Commission Agenda Report

Subject: Coastal Development Permit No. 21-045 – An application to construct a new 594 square-foot Accessory Dwelling Unit/Second Unit on a proposed second building pad in the Malibu Country Estates Overlay (Continued from December 1, 2025)

Location: 24507 Vantage Point Terrace, partially within the appealable coastal zone

CITY OF MALIBU PLANNING COMMISSION
RESOLUTION NO. 26-02

SITE PLAN

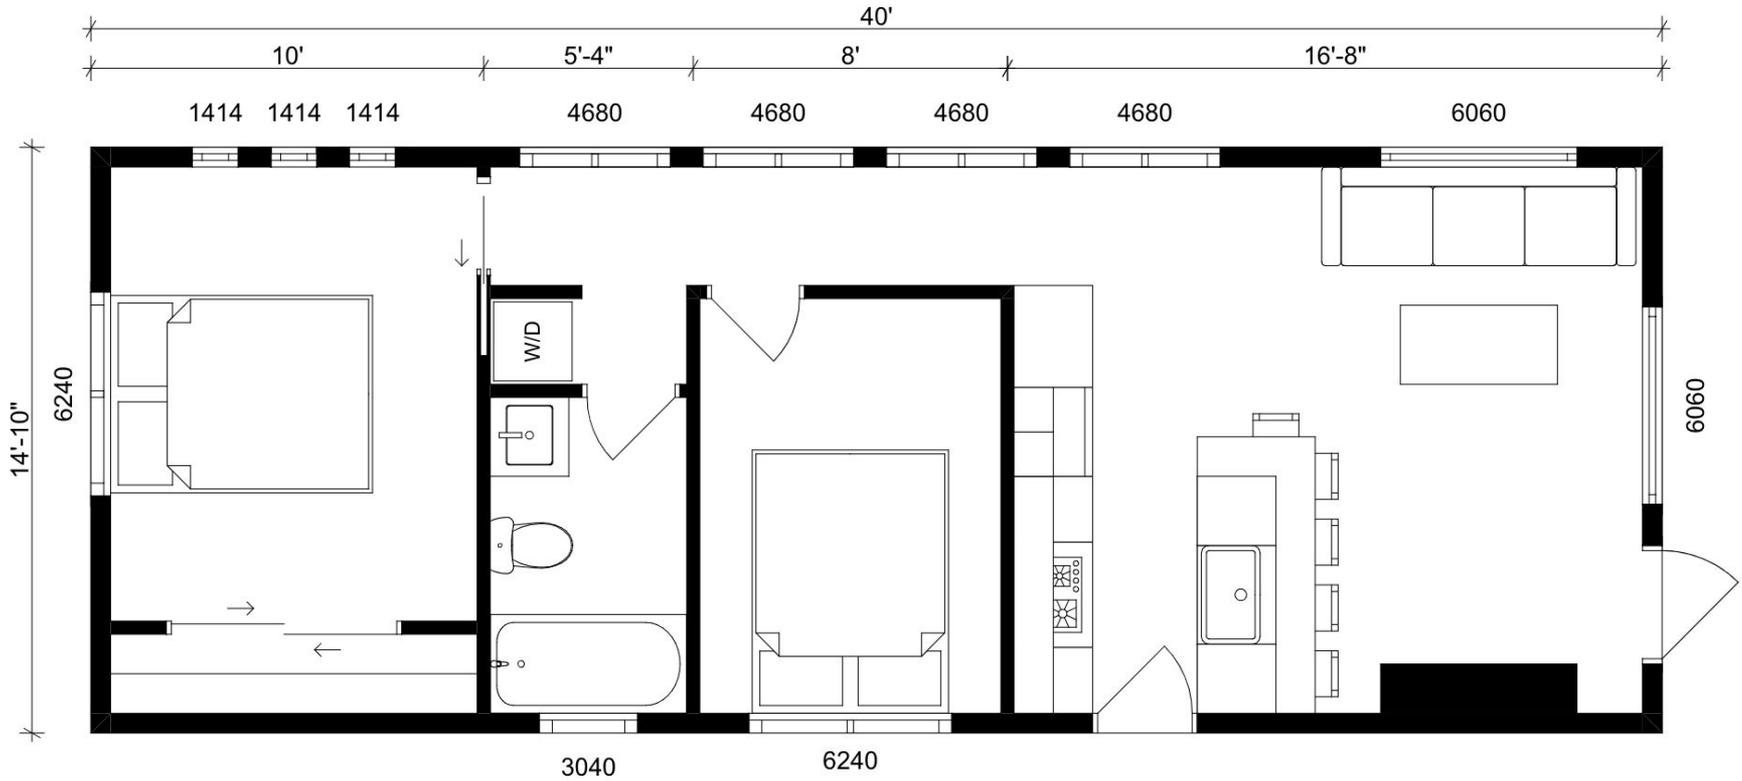
In Figure 1, the existing building pad is located at the top of the slope accessed from Vantage Point Terrace. The existing building pad includes a residence, garage, driveway, front and side yards, walkways, swimming pool, spa, and wooden deck. A 14.83-foot by 40-foot ADU/Second Unit is shown on the rear portion of the parcel downhill from the existing building pad. The ADU/Second Unit is proposed with a 4-foot rear yard setback and a 6-foot 7-inch interior yard setback.

The 1980 aerial photograph further confirms the presence of a second lower pad on Lot 85.

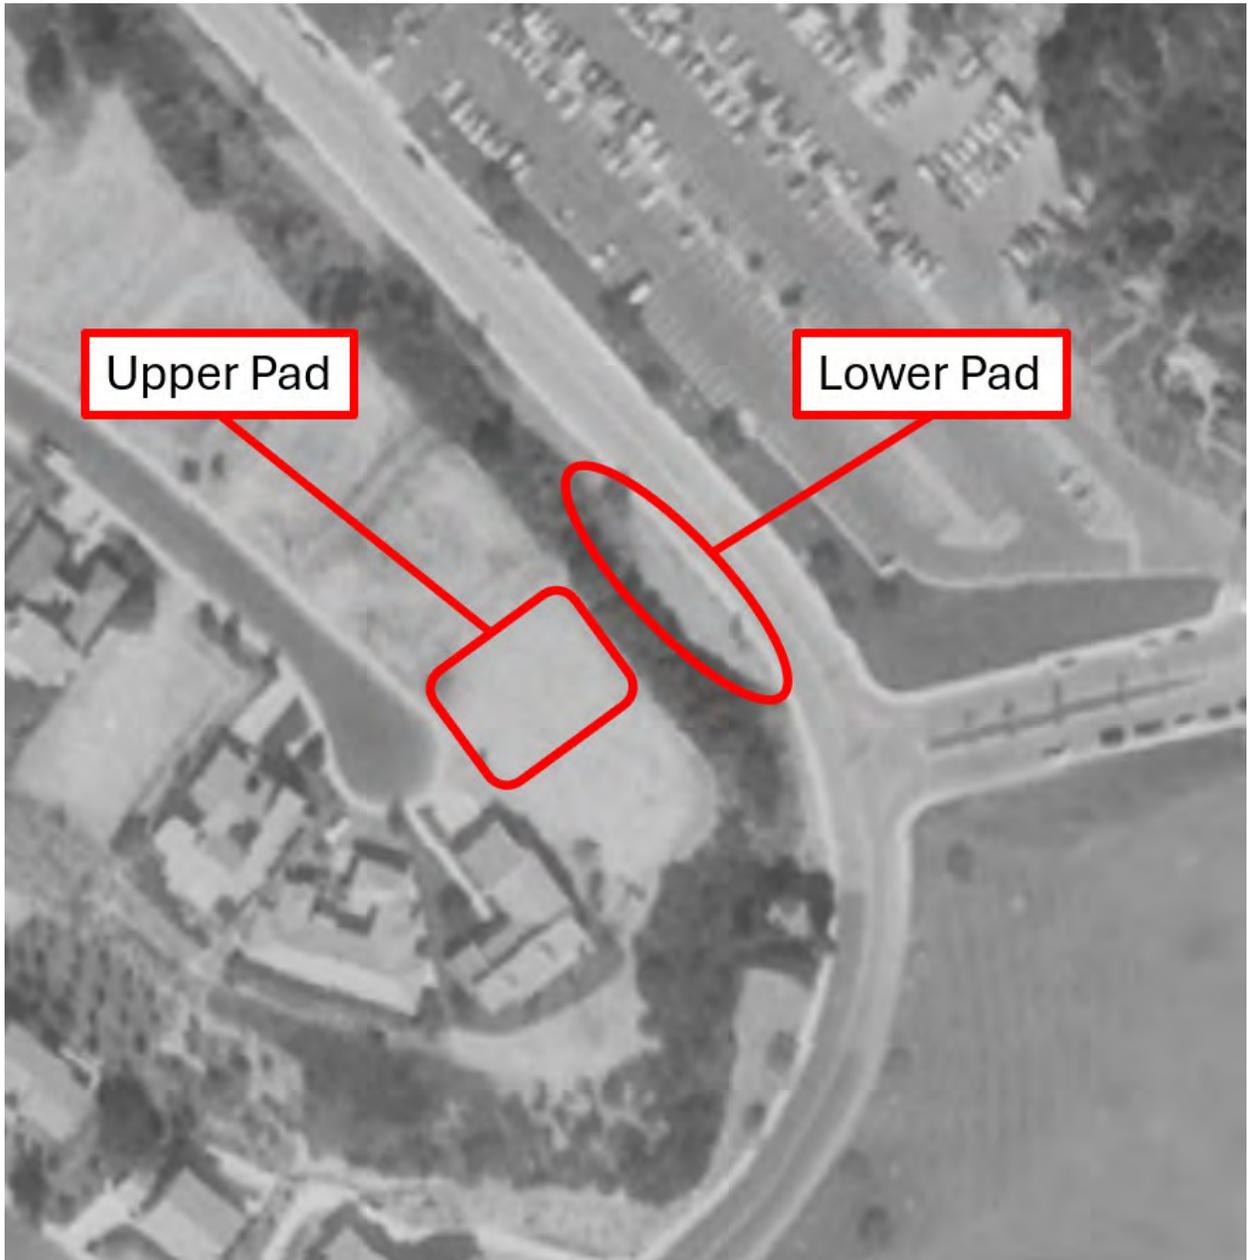
An aerial photograph from 1980 clearly shows that Lot 85 contained two distinct graded pads at that time—prior to the City’s incorporation and adoption of local zoning ordinances, the MCE Overlay District, and the Malibu LCP.

The proposed ADU is not located on a “*proposed building pad*” as staff asserts, but on an existing building pad. As evidenced above, aerial photographs demonstrate that this pad has been in existence since at least 1980. The proposed structure is sited on a pad of less than 3 percent grade, not a slope, and does not extend beyond or cantilever over any downhill slope in accordance with the development standards of the MCE Overlay District.

The parcel contains two existing, legally established building pads. As documented in the attached geotechnical report, the manufactured slope and flat base are comprised of “*well graded*”, compacted, artificial fill, which demonstrates that the existing lower pad was the result of intentional grading. The submitted Geology Report states as follows:

Trees

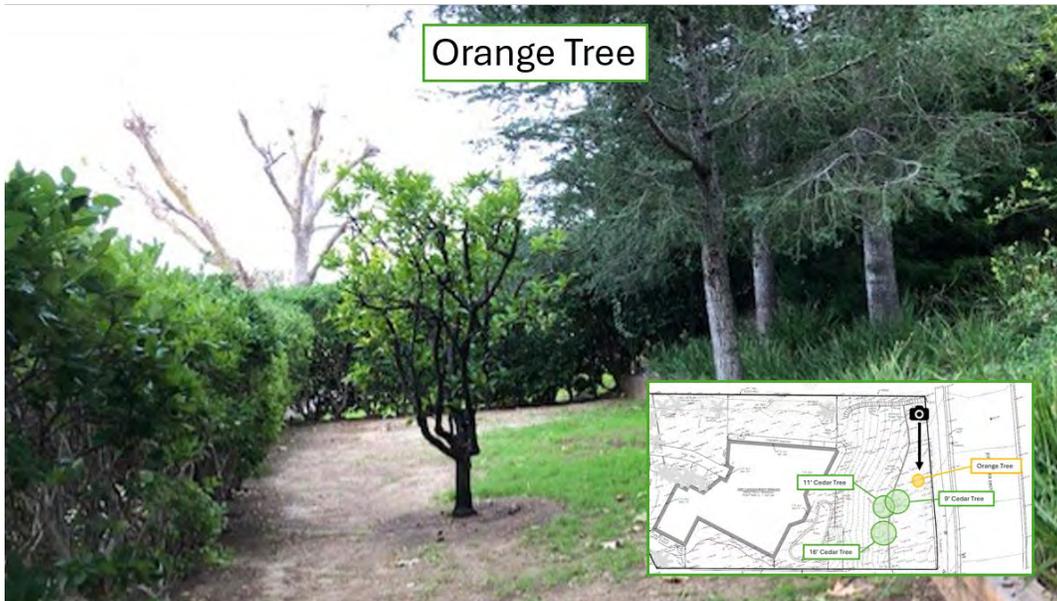
The Staff Report references four trees that were not explicitly identified on the site survey and allude to uncertainties about whether the project is in compliance with Native Tree protection policies of the LCP. To clarify, the identified trees consist of three cedar trees and one orange tree. These are non-native species and are not among the protected trees listed in LCP Chapter 5 (oak, walnut, sycamore, alder, and toyon).

Proposed Location: Lower Building Pad

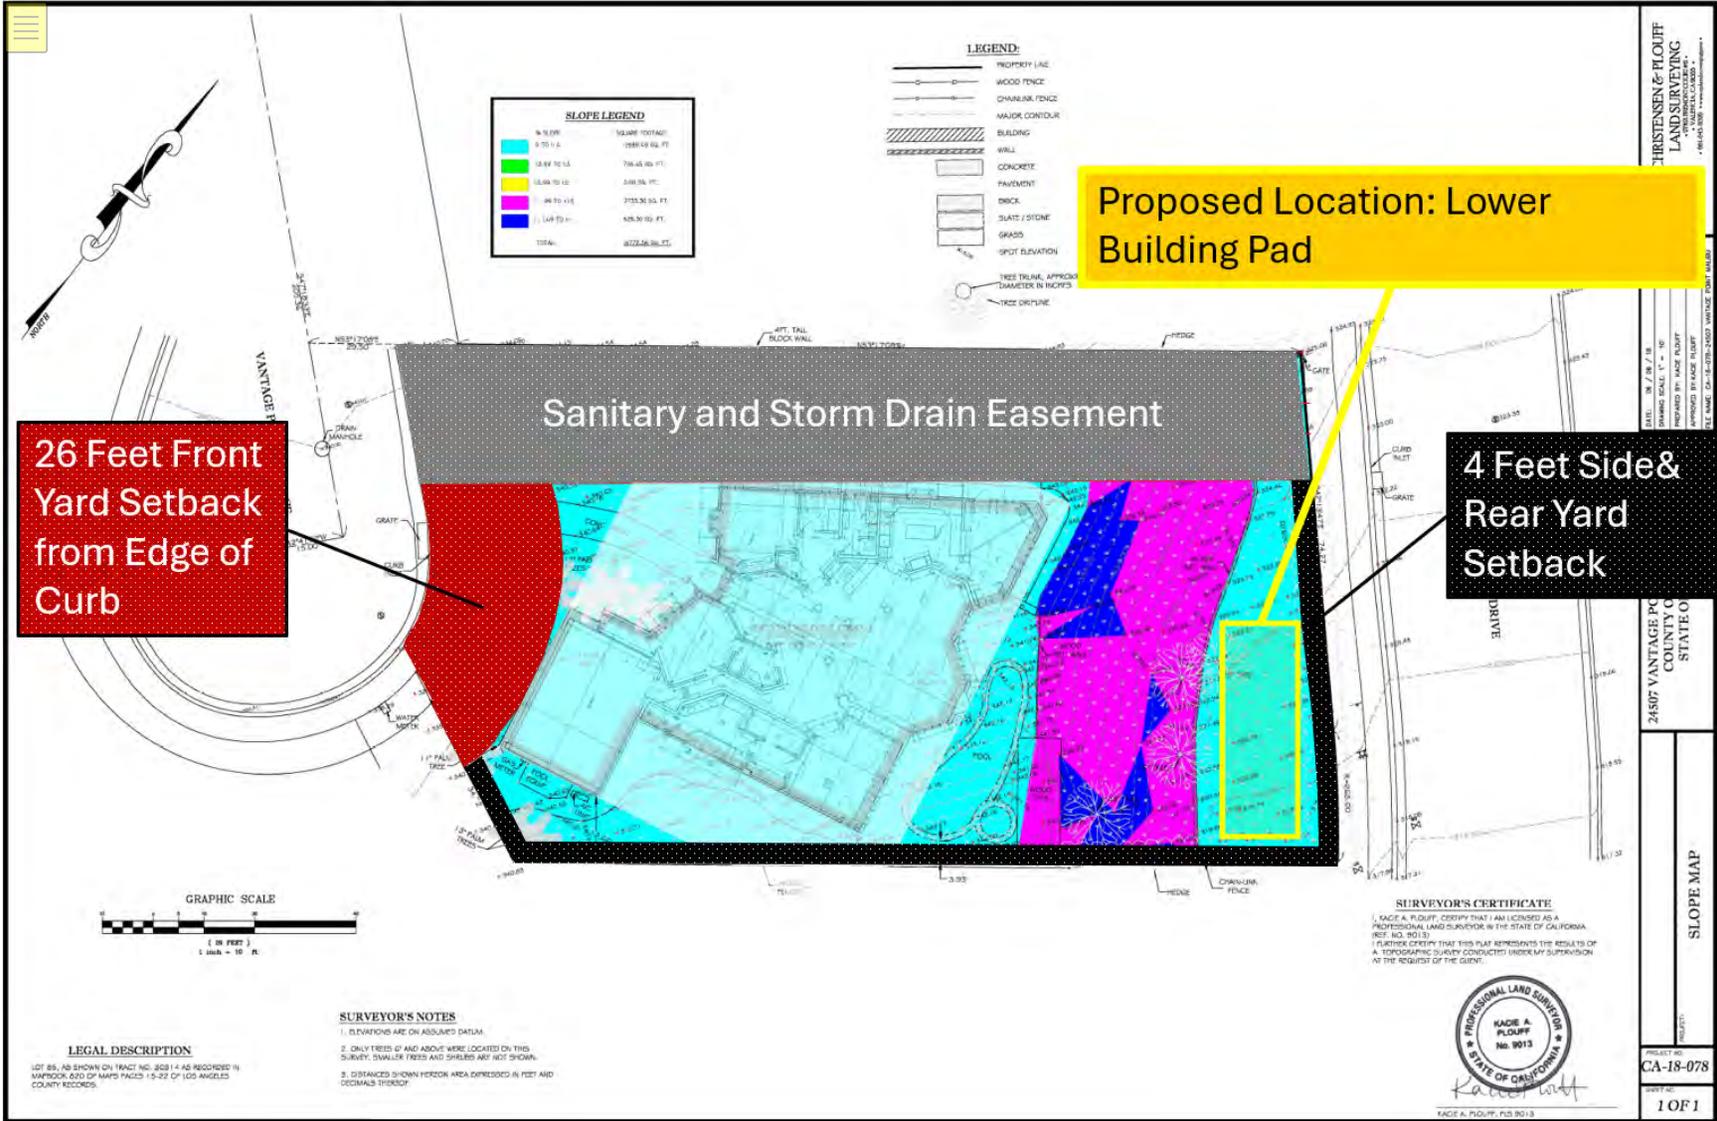
Along the southeastern side, behind the garage and adjacent to the Primary (Master) Bathroom, there is a right triangle of area where it might be assumed that an ADU could be sited. This second alternate shows clearly how after accounting for the master bath’s bay window and the required 6-foot building setback, there is not nearly enough space to squeeze the ADU between the house and the property line, even with the benefit of State ADU law side yard setback reductions. The other half would spill into the setback and over the property line. Therefore, this location is not feasible.

Based on the above analysis, the proposed location appears to be the only feasible location for the proposed ADU, consistent with State ADU law and relevant local ordinances. The proposed location is situated within the allowable front, rear, and side yard setbacks and easements, as required by State ADU law. It does not intrude into neighboring properties. It is not cantilevered over the slope and does not require any non-exempt landform alteration/grading. This location involves the least visible portion of the property, and satisfies State ADU law, Coastal Act policies, and applicable local standards while minimizing environmental, visual, and neighborhood impacts. Thank you for your time and attention to this application.

1st Alternate Location: Over the pool, over the slope

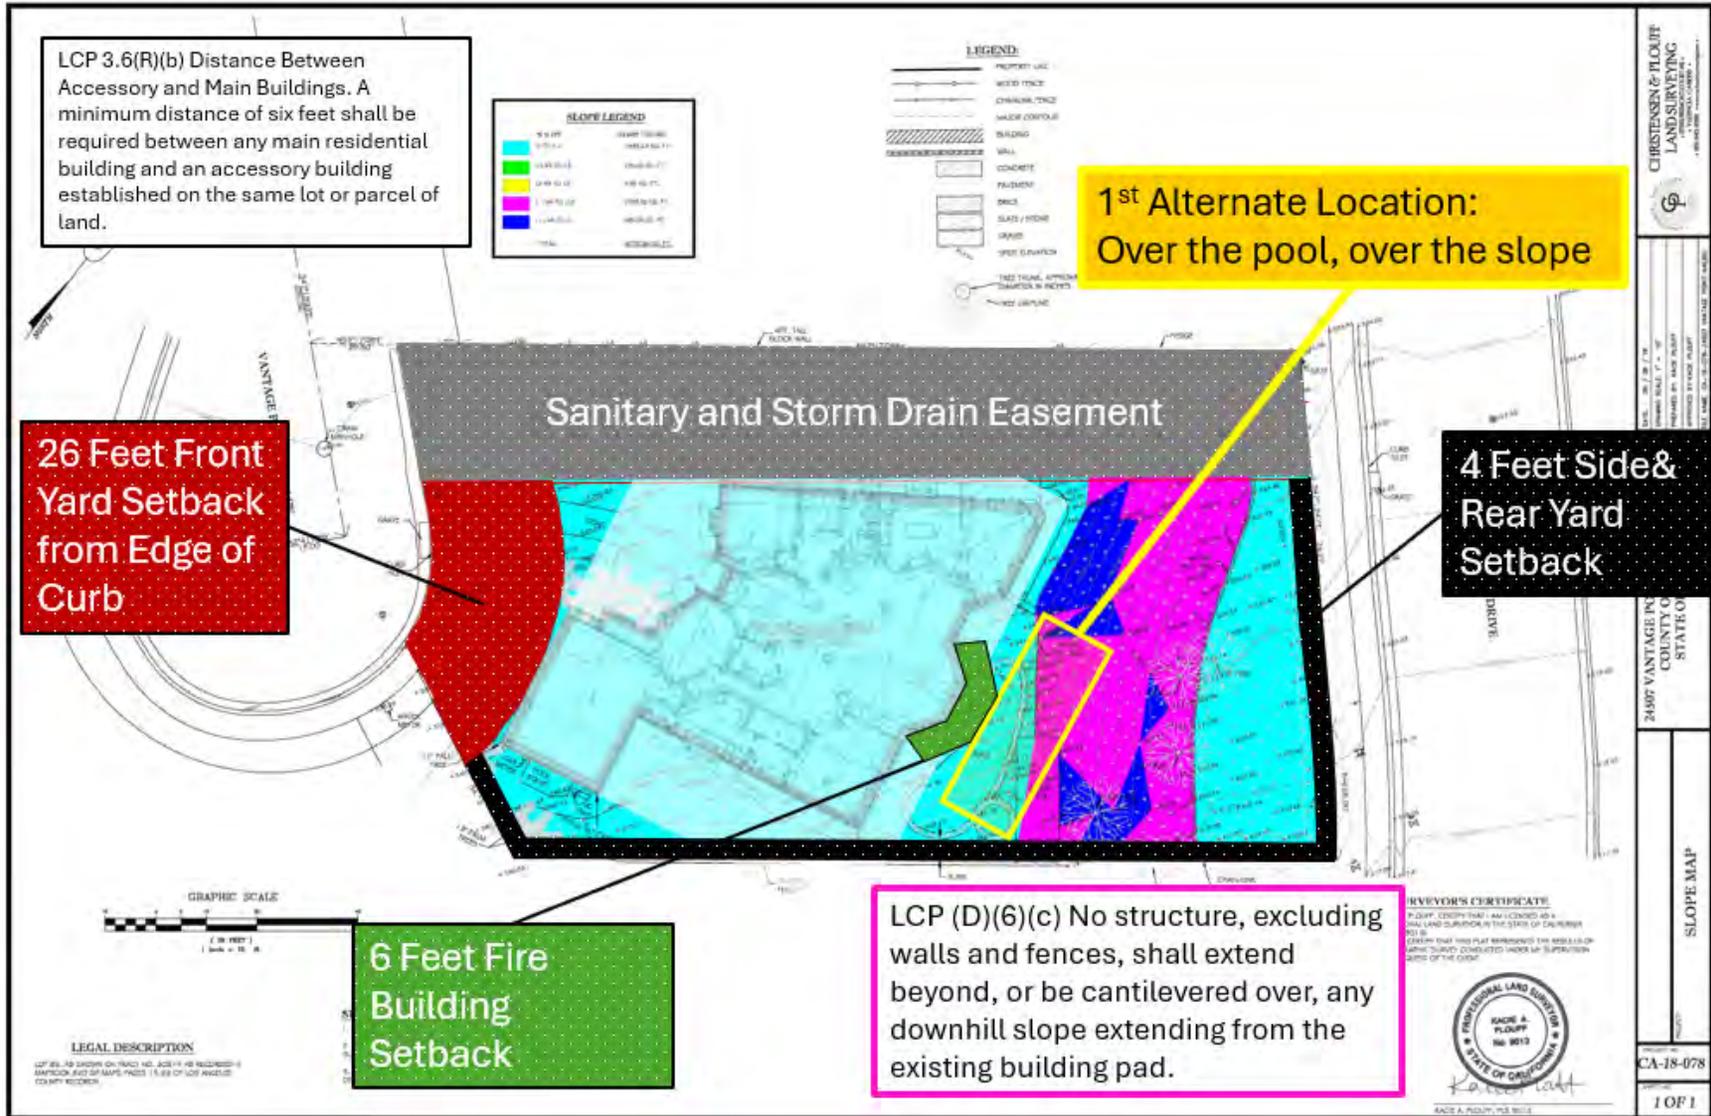
The Staff Report states that, *“the applicant has not provided an alternate design depicting existing constraints to development on the existing building pad or project feasibility/infeasibility at an alternate location.”* To clarify, the applicant submitted a constraints map to City staff on September 7, 2022, which demonstrated significant constraints for development of an ADU on the upper portion of the lot. In order to further clarify the implications of these constraints, our office has included an expanded alternatives analysis, submitted with this response, that clearly depicts the impracticality and infeasibility of siting the ADU in alternative locations.

The Staff report suggests that conversion of the existing garage to an ADU might be a feasible alternative. However, this option would eliminate required on-site covered parking and require property owner vehicles to be parked on a cul-de-sac with limited street parking. This would be in opposition to one of the stated purposes of the LCP: *“1.2. PURPOSE (H.) To lessen congestion on the streets and provide for adequate off-street parking.”*
